Revised Cartridge & Chamber 6.5 Grendel (6.5 GREN)

Date
Revised:
4/27/2026

6.5 GRENDL [6.5 GREN]

MAXIMUM CARTRIDGE / MINIMUM CHAMBER

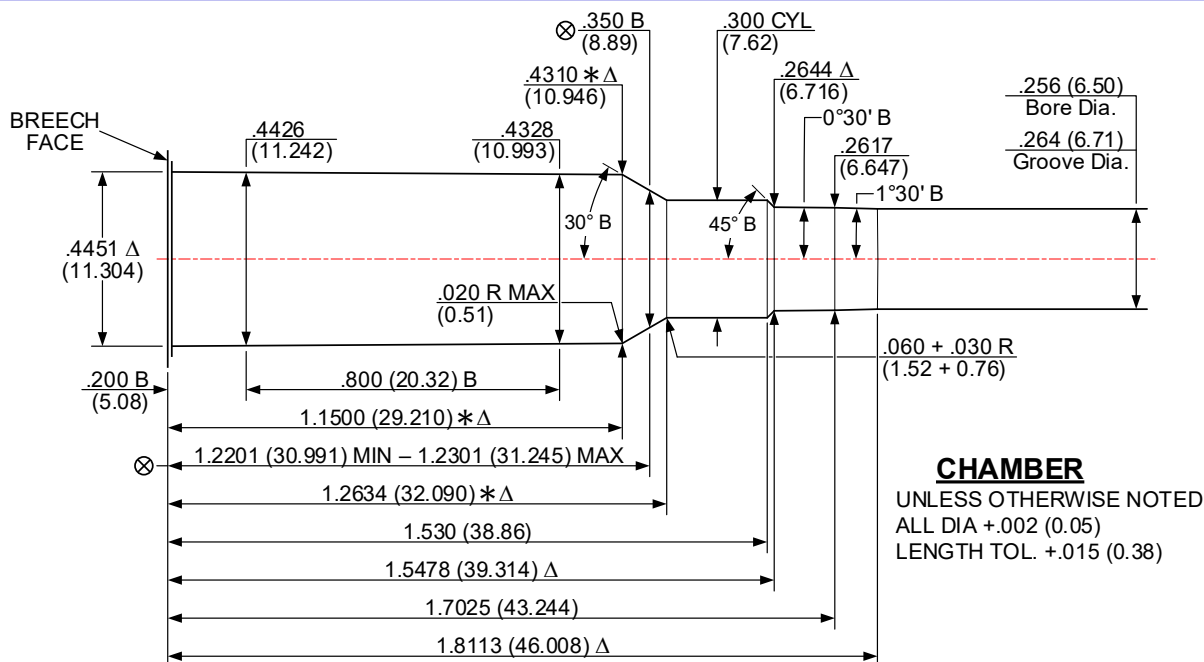
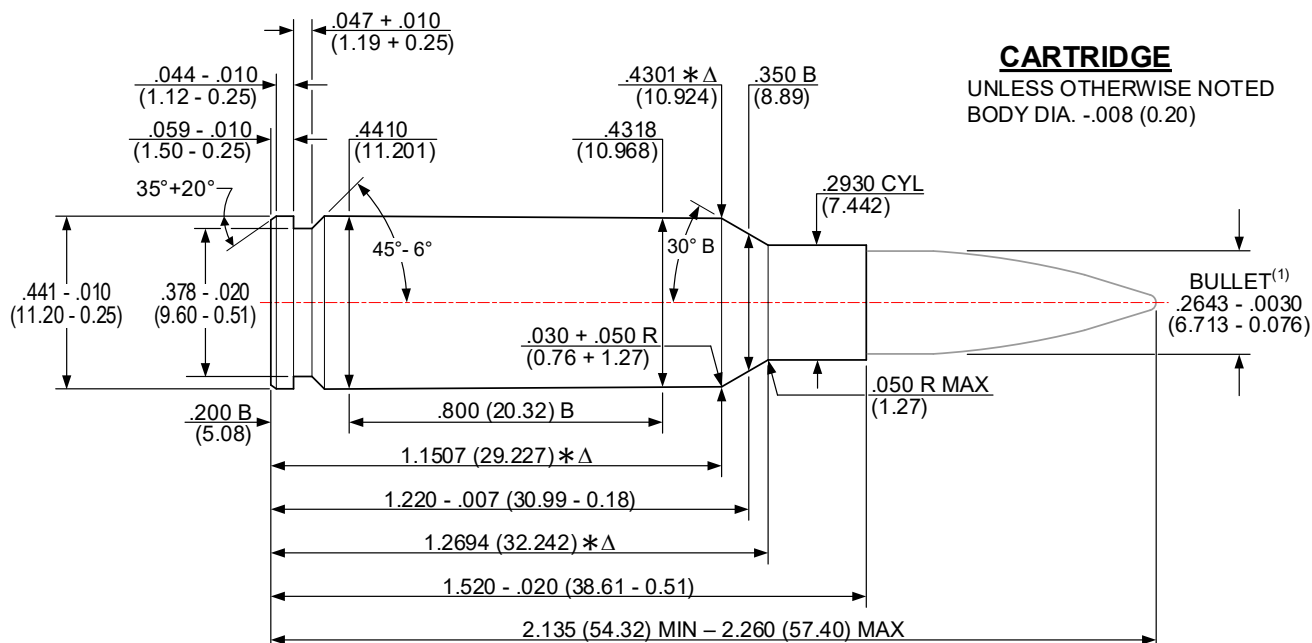
¹ This revision corrects the metric length of the breech face to shoulder/neck intersection from (30.090) to (32.090).
